**RE: Exhibition of MP 11\_0002 Residential Buildings R8 and R9, Block X, Barangaroo South.**

NSW Trade & Investment (Industry, Innovation and Investment & Arts NSW) has undertaken a review of the EA and provided the comments in Attachment A.

**Site Staging Plan Sheet 1 (Dwg: 210079-DA-830)**

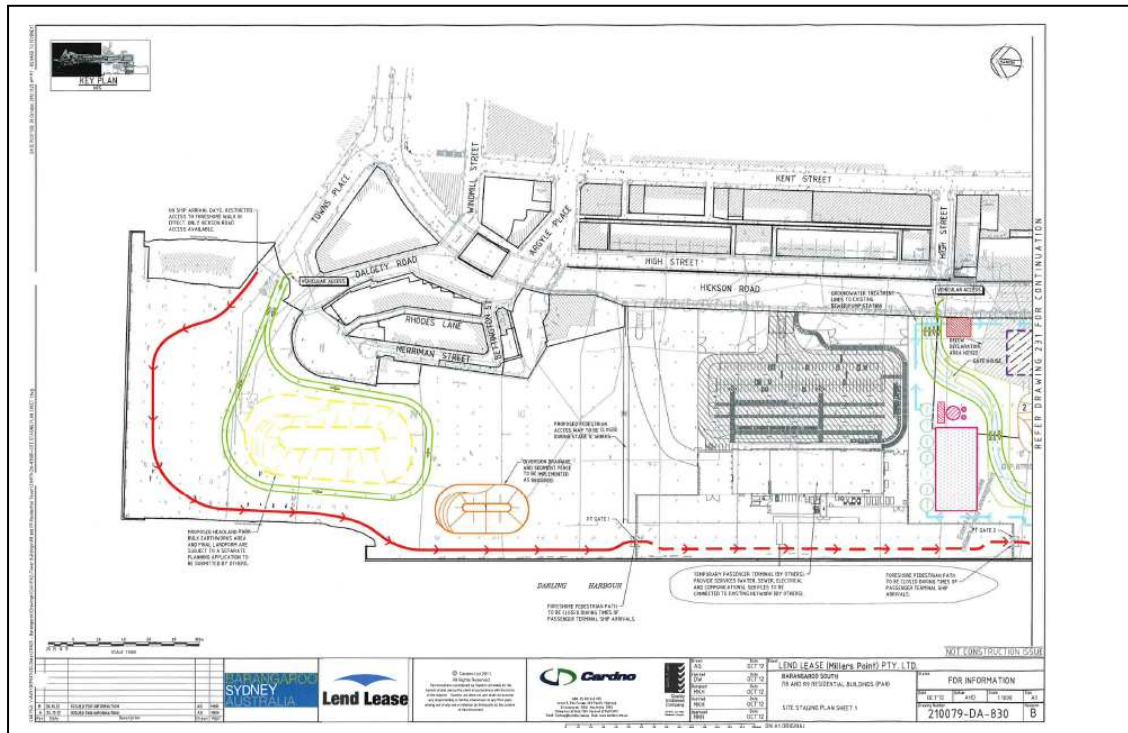
- Appendix CC – “*Environmental, Construction and Site Management Plan*” by Lend Lease documents impacts of construction. Heavy truck haulage movements will have a noise impact on Hickson Road & Walsh Bay (Wharf 4/5 being only 550 metres) with truck entry / haulage route at proposed Headland Park, at the intersection of Towns Place & Dalgety Roads, (refer below *Site Staging Plan Sheet 1*). Arts NSW preference is to minimise heavy truck movements along Hickson Road, north of Towns Place that would heavily impact Walsh Bay, with a preference for haulage movements to be south along Hickson Road.

- Appendix EE – “*Construction Traffic Management Plan*” by Arup includes documentation of construction traffic and heavy vehicle movements associated with Headland Park Early works - proposes for example 100 semi-trailer low loaders for earth moving equipment delivery and haulage and excavation off-site truck movements of up to 20 per week day, 3 truck movements per hour. This heavy truck traffic will impact on the amenity of Walsh Bay during the construction phase. Arts NSW requests that notification be provided during the peak construction period to ensure that informed advice can be provided to residences and tenants of Arts NSW properties at Walsh Bay.

- Arts NSW has concerns regarding the heavy truck movements along Hickson Road during peak pm periods with confirmation of traffic circulation routes to be confirmed. Noise and vibration impact at the latter end of the working days will potentially impact visitor experience and enjoyment of the arts and cultural activities in Walsh Bay (Wharf 4/5 & Sydney Theatre).
